**State of Alaska
Department of Fish and Game
Sportfish Division**

**Nomination Form
Anadromous Waters Catalog**

Region Southcentral USGS Quad(s) SELDOVIA B-4
 Anadromous Waters Catalog Number of Water Body 241-16-10245 (-2005), 241-16-10240
 Name of Water Body *Sadie Head End (Right & Left Creek) USGS Name Local Name
 Addition Deletion Correction Backup Information

Nomination # <u>25-883</u>		<u>12/26/2025</u>
Revision Year: <u>2026</u>	Fisheries Scientist	Date
Revision to: <input checked="" type="checkbox"/> Atlas		<u>12/24/25</u>
<input checked="" type="checkbox"/> Catalog	Habitat Operations Manager	Date
Revision Code: <u>C-9, C-7, C-1a, B-1, D-1</u>		<u>12 Dec 2025</u>
<u>3</u>	AWC Project Biologist	Date
		<u>12/31/2025</u>
	GIS Analyst	Date

Map # 3

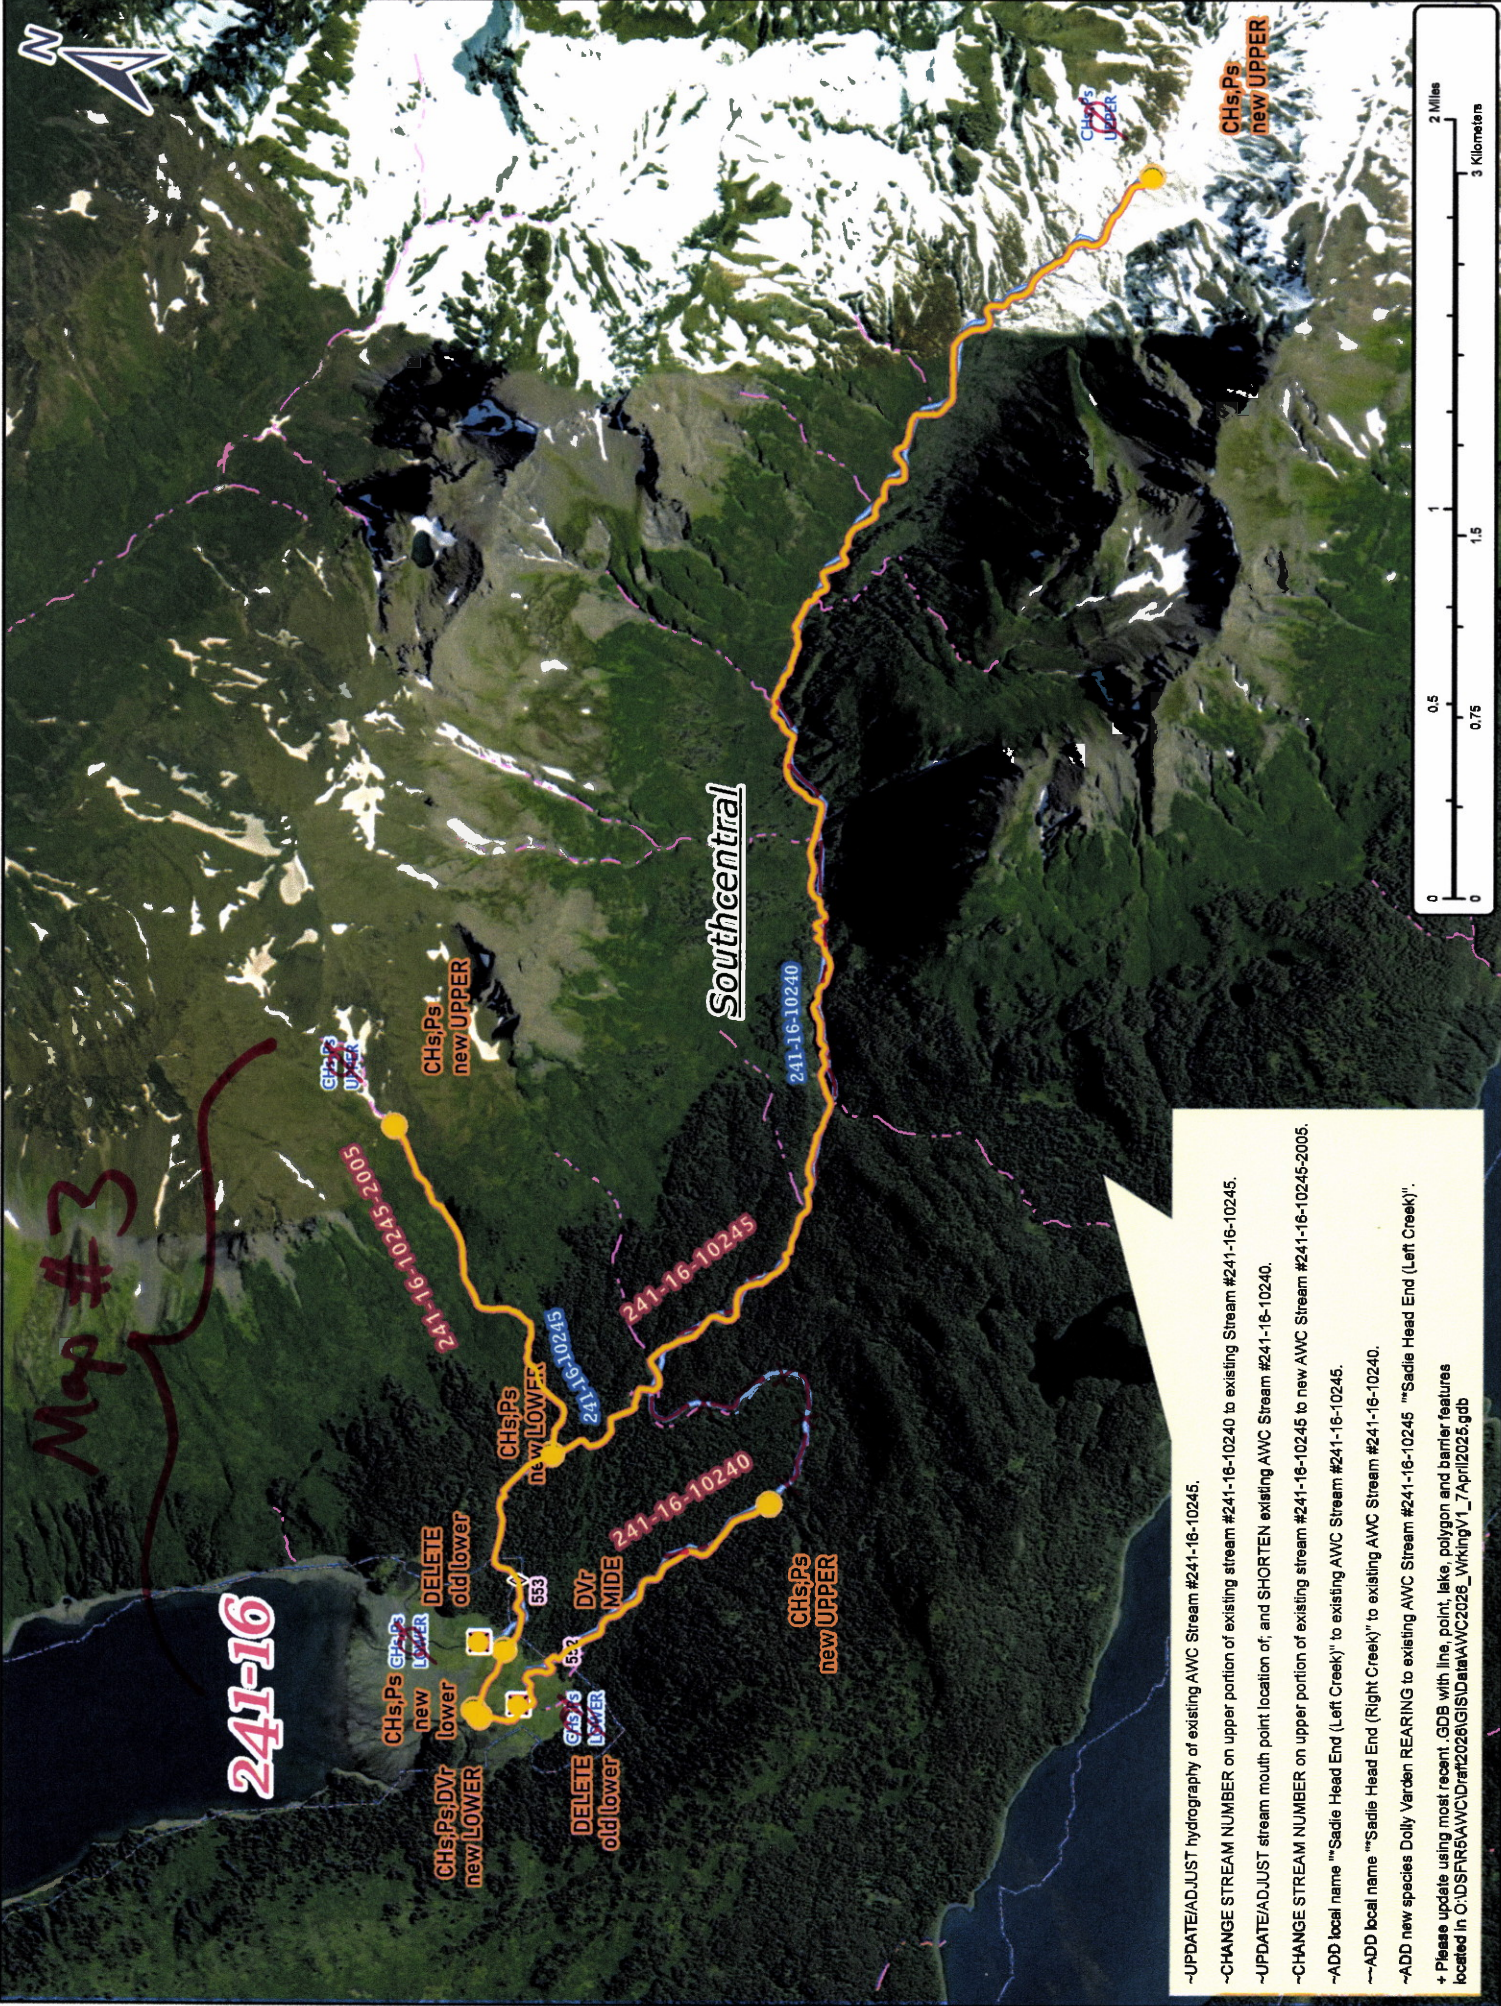
Nom. #25-883 ~ Google Earth Imagery dated Sept 2025 depicts the current hydrology here (red section) where the upper extent of 241-16-10240 should be the upper extent of #241-16-10245.

Map # 2

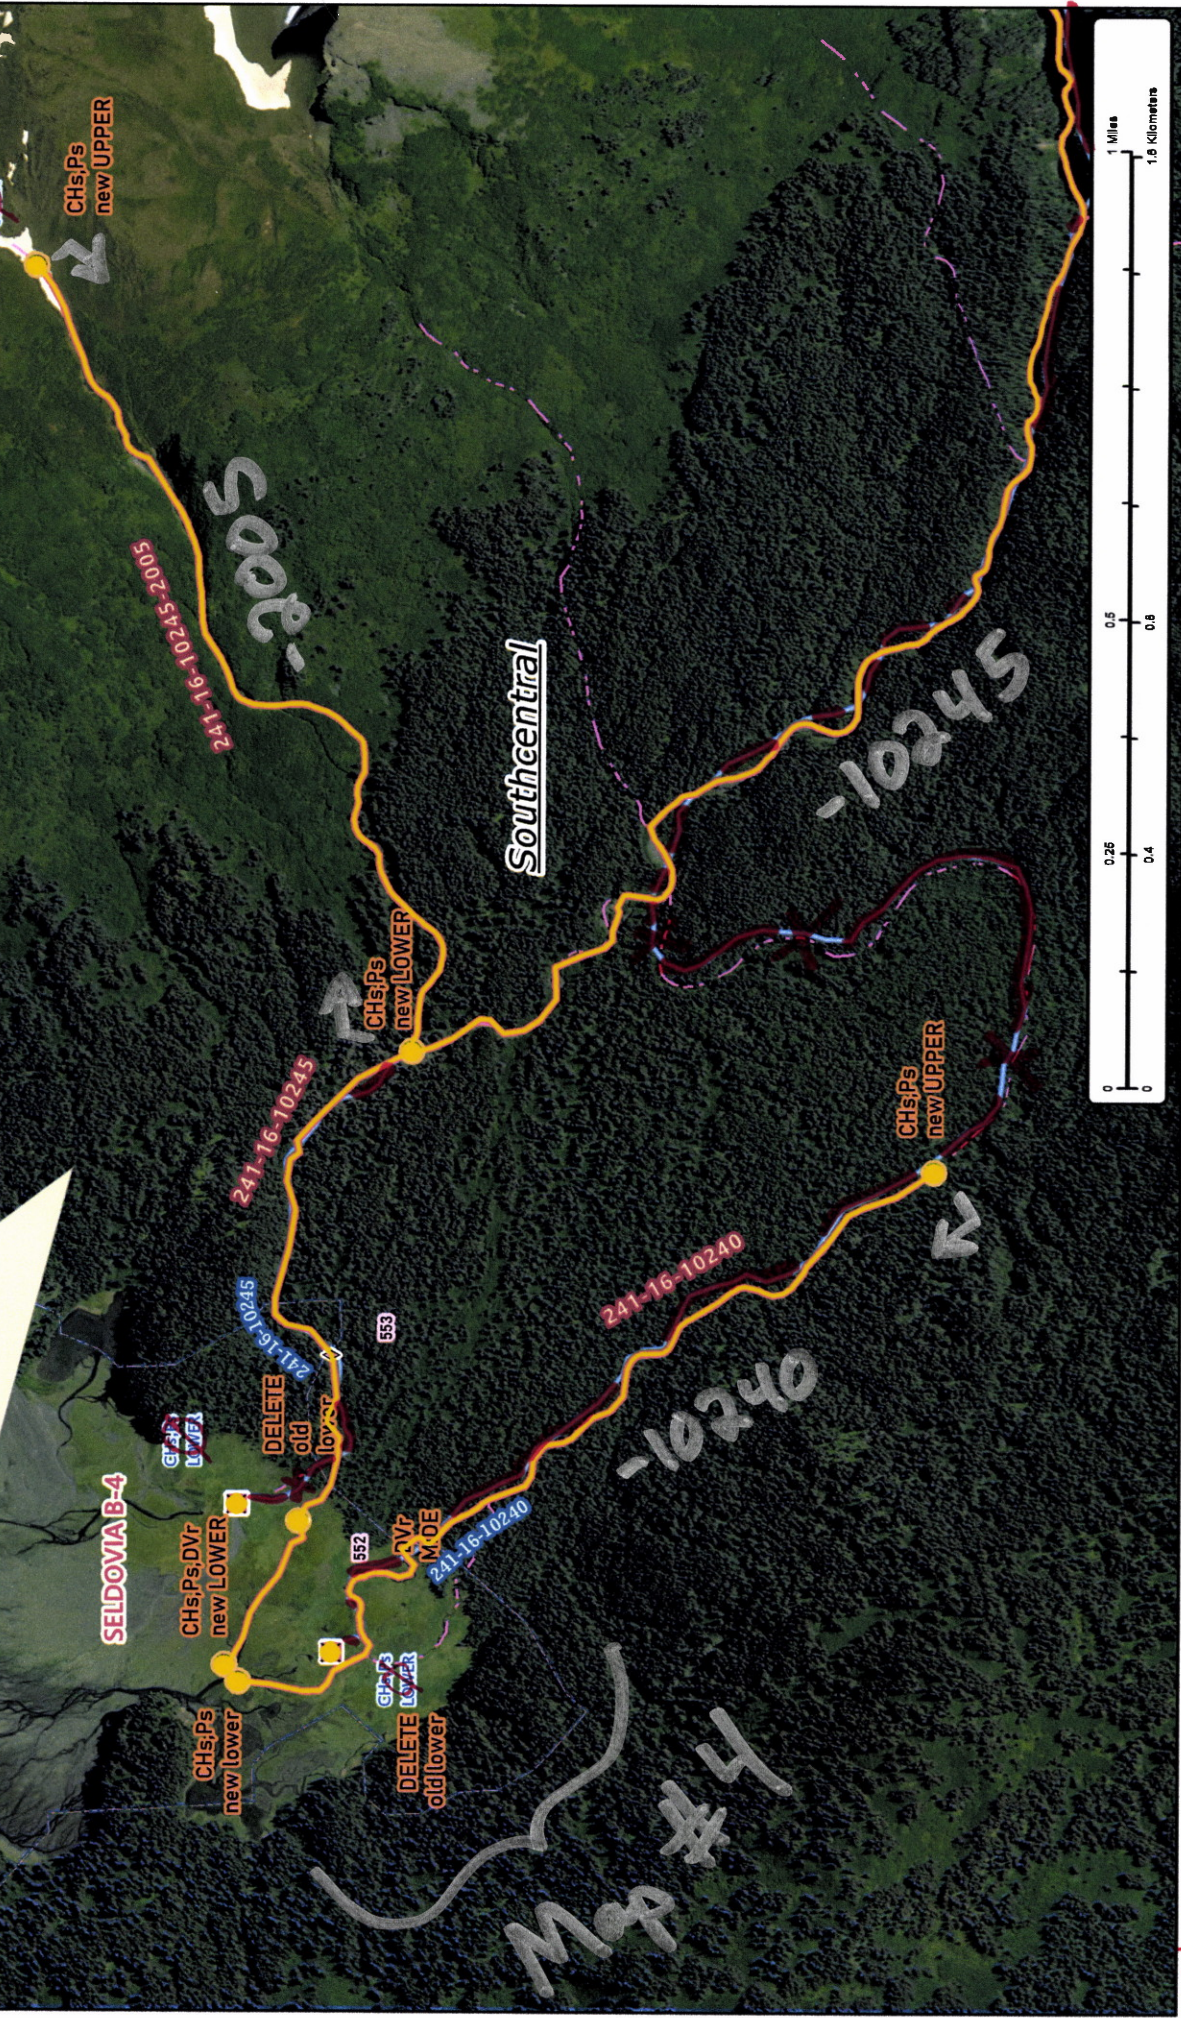
- UPDATE/ADJUST hydrography of existing AWC Stream #241-16-10245.
- CHANGE STREAM NUMBER on upper portion of existing stream #241-16-10240 to existing Stream #241-16-10245.
- UPDATE/ADJUST stream mouth location of, and SHORTEN existing AWC Stream #241-16-10240.
- CHANGE STREAM NUMBER on upper portion of existing stream #241-16-10245 to new AWC Stream #241-16-10245-2005.
- ADD local name "Sadie Head End (Left Creek)" to existing AWC Stream #241-16-10245.
- ADD local name "Sadie Head End (Right Creek)" to existing AWC Stream #241-16-10240.
- ADD new species Dolly Varden REARING to existing AWC Stream #241-16-10245 "Sadie Head End (Left Creek)".
- + Please update using most recent GDB with line, point, lake, polygon and barrier features located in C:\DS\FRA\AWC\ID\ref2026\GISData\AWC2026_WorkingV1_7April2025.gdb
